# SERVICE INSTRUCTION

Service Instruction No. 1509  
Engineering Aspects are  
FAA Approved

SUBJECT: Replacement of All P/N STD-1409 Nuts with P/N STD-2249 Nuts

MODELS AFFECTED: All Lycoming aircraft engines.

Figure 1.

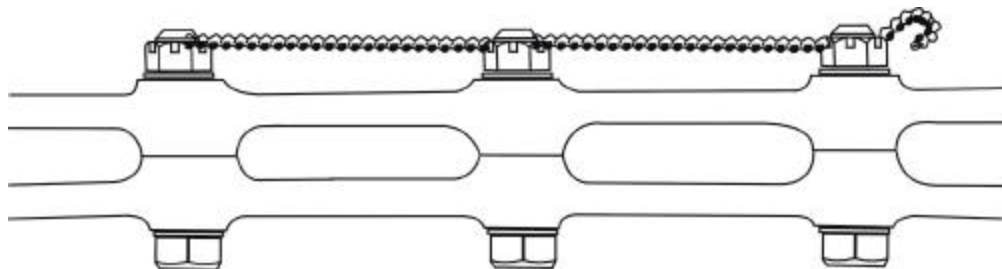
Any time a P/N STD-1409 nut is removed from the crankcase parting line in the sump or from any other location (such as the oil pump body on TIO and TIGO-541 models, the magnetos and oil pump support on VO-360 and IVO-360 models, the oil suction tube on O-235 and O-320 models, and other applications), it should be replaced with P/N STD-2249 slotted nut.

The new P/N STD-2249 nut is to be torqued to 55 in.-lbs. and safety-wired (see Figure 1, below, for typical view of use in crankcase parting line in the sump).
